RESPONSE TO FLORIDA DEPARTMENT OF ENVIRONMENTAL PROTECTION COMMENT ON SITE 3 TECHNICAL MEMORANDUM FOR NAS CECIL FIELD FL

RE: Response to Comments
Site 3 Technical Memorandum
Former NAS Cecil Field, Jacksonville, Florida
Contract No: N62470-11-D-8013
CTO JM76

Please note the following responses to comments received from the Florida Department of Environmental Protection on April 10, 2015. These responses to comments are associated with the attached Site 3 Technical Memorandum dated July, 2015 (Revision 1).

FIGURE 3-1
ANALYTICAL RESULTS MAP
OU8, SITE 3
FORMER NAS CECIL FIELD
JACKSONVILLE, FLORIDA

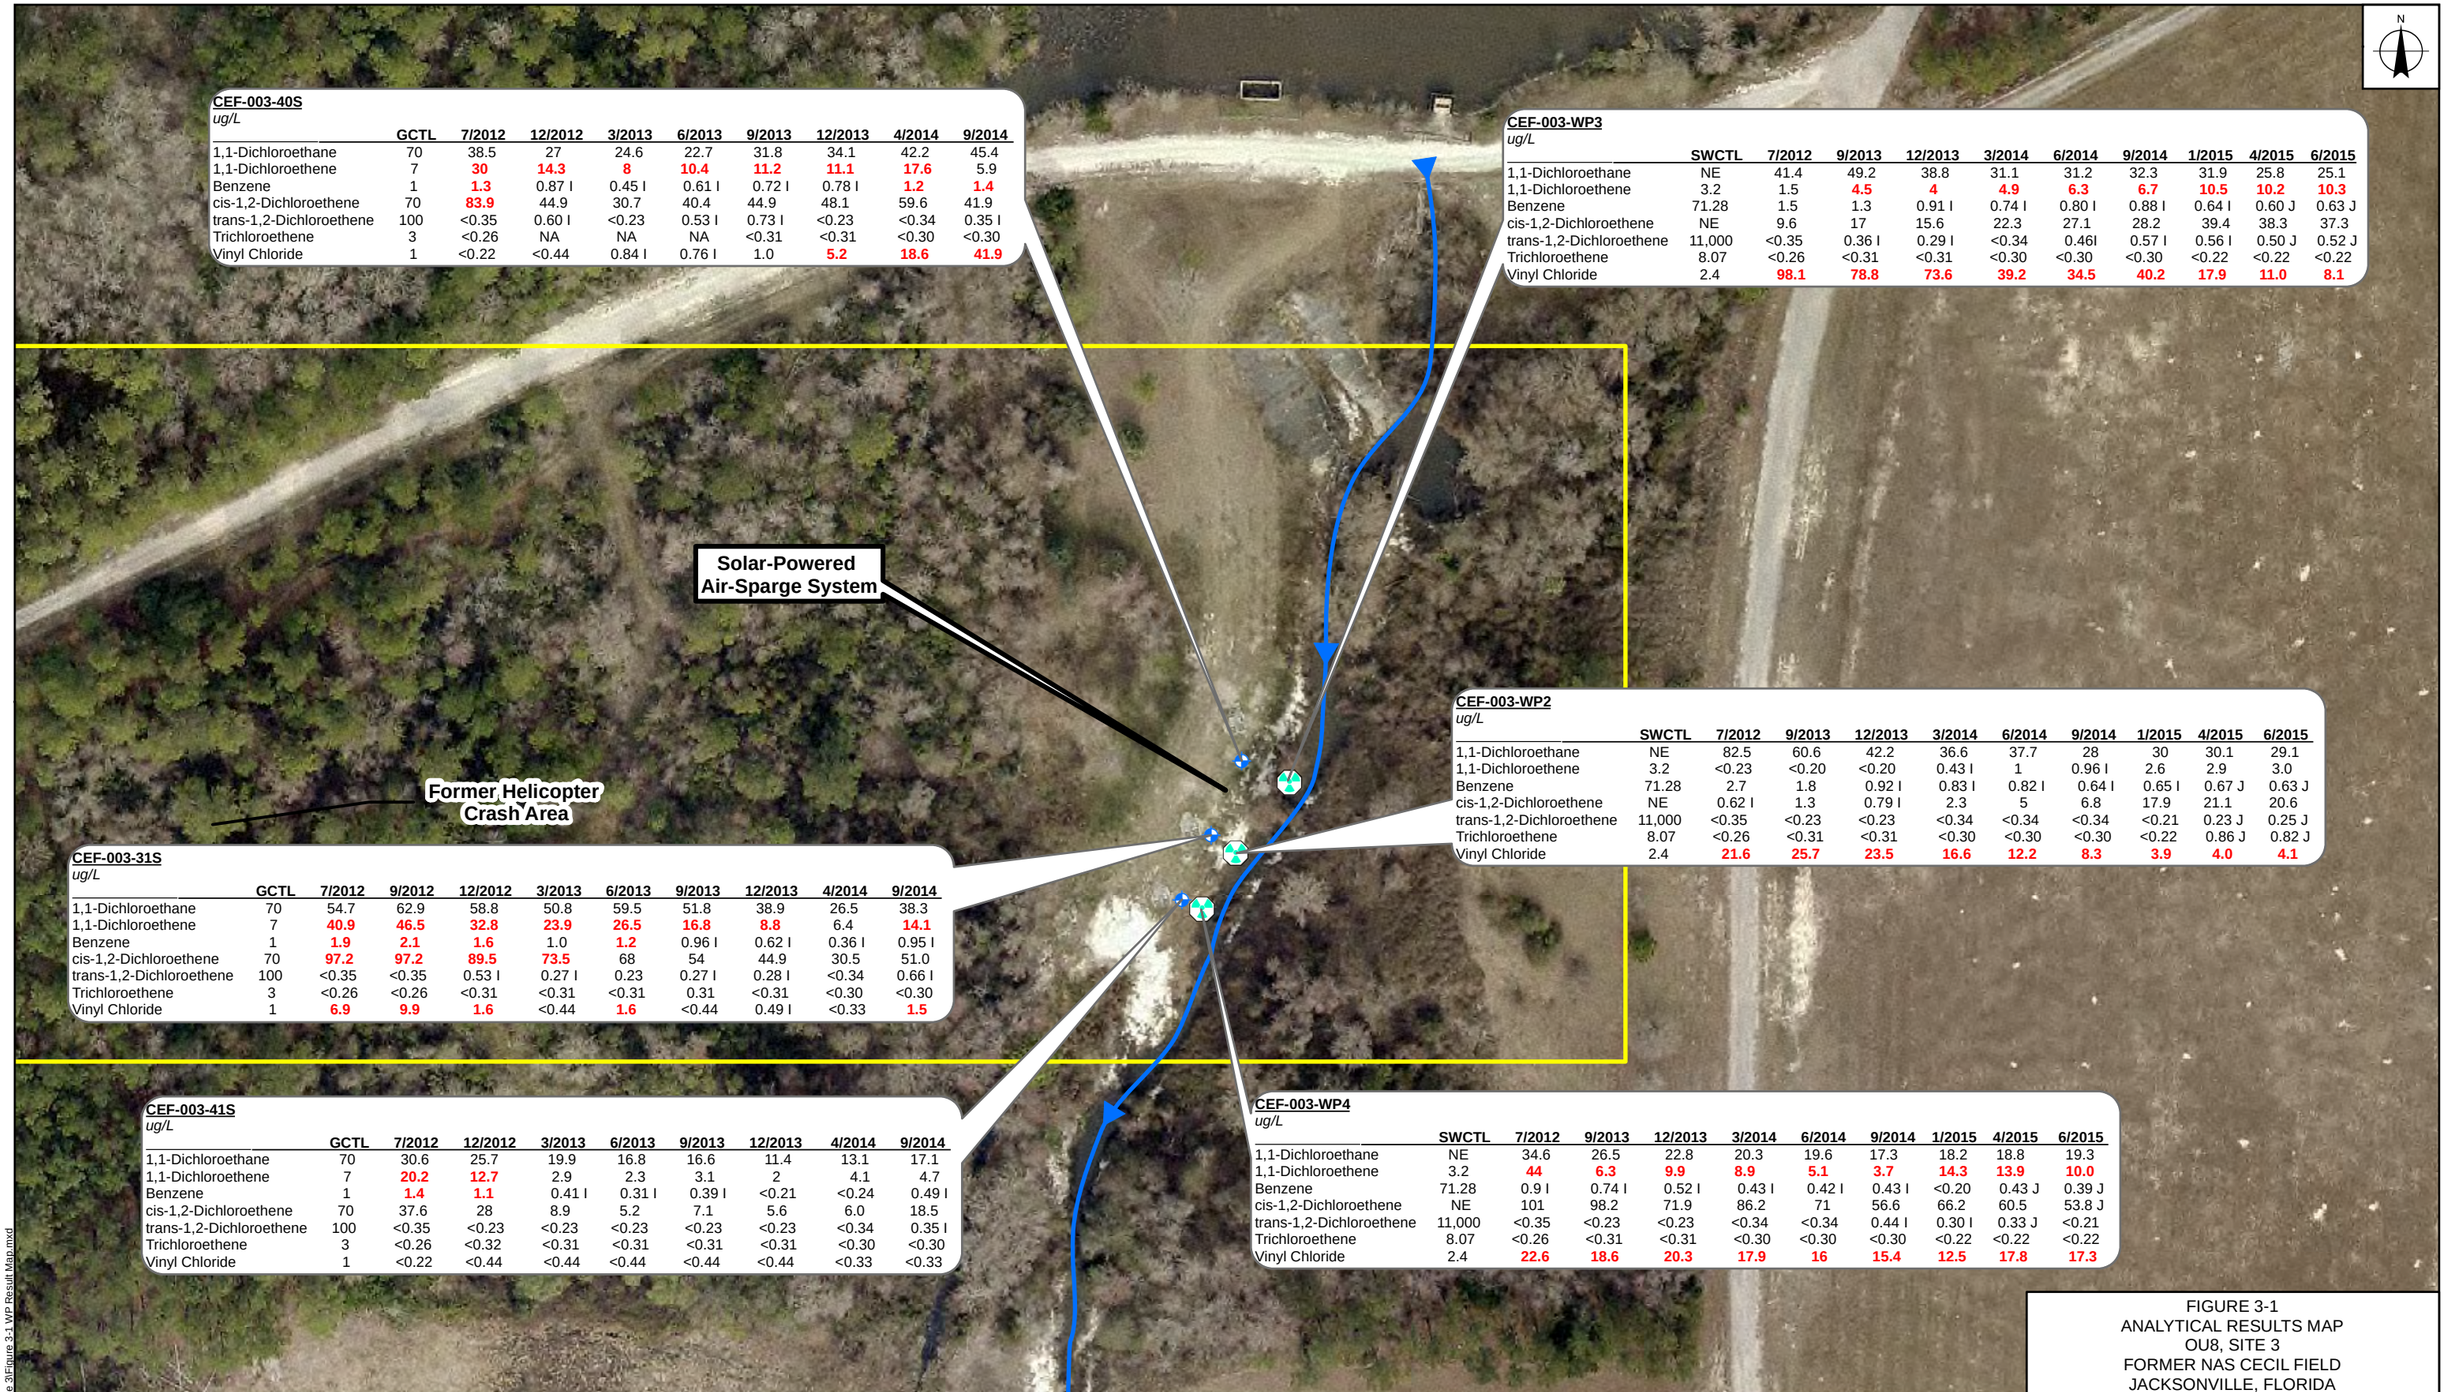
It states in the bottom paragraph that "Surface water samples were inadvertently collected from Rowell Creek instead of well points during quarterly sampling events from December 2012 through December 2013." It also states in that paragraph that analysis of those samples indicated that chemicals of concern associated with Site 3 were not detected. These statements conflict with the information provided in Table 3-1 and Figure 3-1, which indicate that samples were collected from three well points in September and December 2013 and that analysis of those samples show detected concentrations of various chemicals of concern, with concentrations of 1,1 dichloroethene and vinyl chloride above their respective surface water cleanup target levels. Please correct this inconsistency.

In Table 3-1 and in Figure 3-1, the analytical results for well CEF-003-31S has the September 2012 data reported before the July 2012 data. Please verify whether the September 2012 data is actually from that date or if it may be from September 2011.

Sample results shown in Table 3-1 and Figure 3-1 for the three well points (CEF-003-WP2, CEF-003-WP3, and CEF-003-WP4) are accurate. Language in the associated paragraph will be clarified. Results for sampling collected directly from the surface water of Rowell Creek between December 2012 and December 2013 are not shown in Site 3 Technical Memorandum

Table 3-1 and Figure 3-1 have been revised to show results in chronological order for monitoring well CEF-003-31S.
